Annex E

Cumulative Impact Tables

Landscape Proof of Evidence on behalf of

Planning Inspectorate Appeal Reference: APP/Q3115/W/24/3358132

Figure E1: STRAT 8 & 9 Indicative Concept Plan

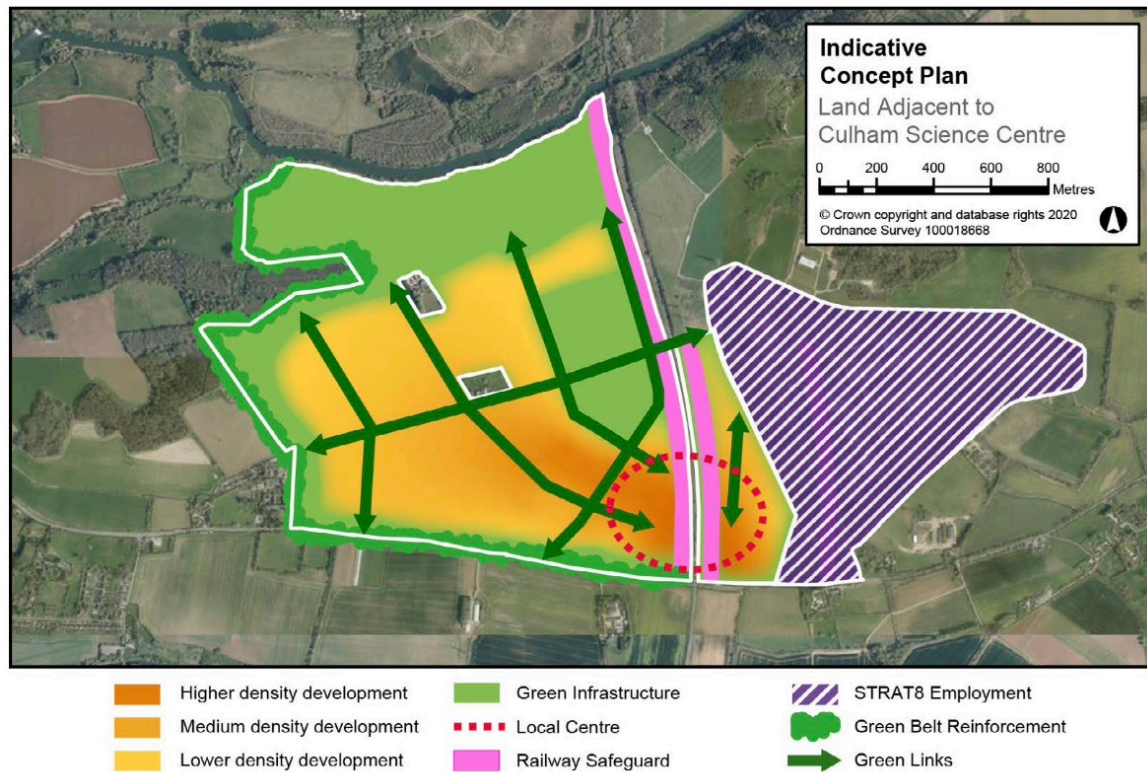
- E6. Stand-alone significant visual impacts have also been identified on the new SRTAT 9 settlement and users of the long-distance Oxfordshire Green Belt Way route. This assessment considers cumulative effects with just the STRAT 8 & 9 area. The local plan concept diagram (**CD 3.4.1**) is included below for ease of reference.

- E7. The cumulative visual effects will extend over approximately 800m for users of the Oxfordshire Green Belt Way in both directions. Users in the absence of the Appeal Scheme will move through a series of spaces on the edge of the STRAT 8 & 9 area with the allocation development on one side of their view. The addition of the Appeal Scheme will place development on both sides of the view. The magnitude of additional change would be high, creating a substantial cumulative effect.
